KENYA ELECTRICITY GENERATING COMPANY PLC

TENDER No. KGN-HYD-013-2019

TENDER FOR SUPPLY INTAKE AND SPILLGATE SEALS FOR KAMBURU, KINDARUMA & MASINGA POWER STATIONS

CLARIFICATION No. 2

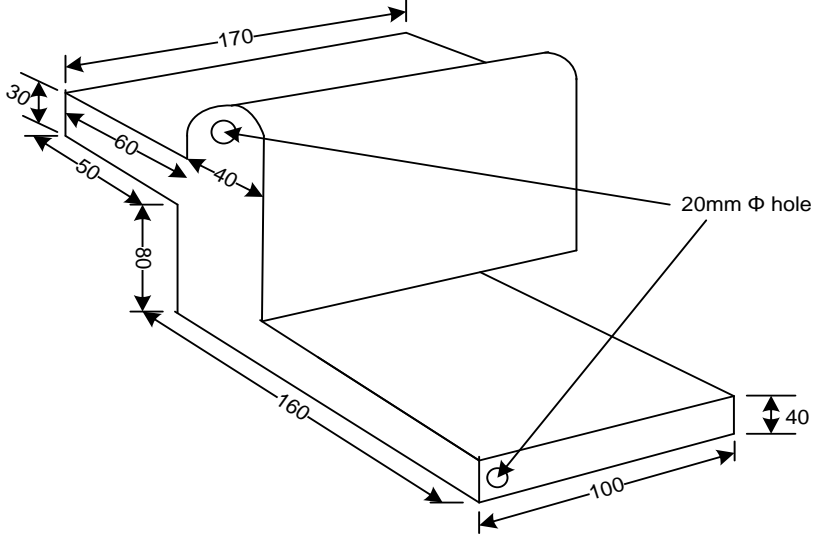
ITEM NO.	PRICE SCHEDULE ITEM NO.	CLARIFICATION	DRAWING
1	Item 1	Supply 6 pieces each of left and right side corner seals (mirror reflection)	 <p>A 3D perspective drawing of a corner seal. The dimensions are: top length 170, top thickness 30, top offset 60, top offset 50, height 88, bottom length 160, bottom width 100, bottom thickness 40, and a 20mm diameter hole. A label '20mm Φ hole' points to the hole.</p>
2	Item 2	Length of seal given on the drawing should be 14000mm and not 1400mm as earlier given.	 <p>A 3D perspective drawing of a long seal. The dimensions are: width 100, height 40, and length 14000. A label '20mm Φ hole' points to the hole.</p>

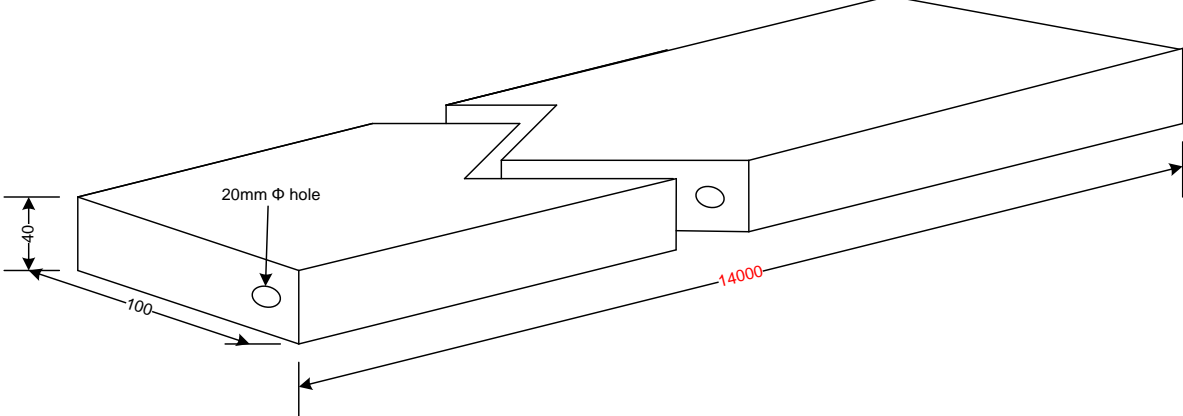
3	Item 3	Two dimensions had been left out on the initial drawing. This has now been included and in red as per attached revised drawing.	<p>The drawing shows a mechanical part with the following specifications:</p> <ul style="list-style-type: none"> Overall length: 220 Overall width: 115 Overall height: 35 Top surface features: <ul style="list-style-type: none"> Two $\phi 21\text{mm}$ holes, each 27mm deep. Two $\phi 40\text{mm}$ holes. Two $\phi 16\text{mm}$ holes. Dimensions in red (revisions): <ul style="list-style-type: none"> 110 (width of a top section) 70 (width of a sloped section) Other dimensions: 25, 40, 60, 115, 180, 10, 40, 10, 60, 57.
---	--------	---	---
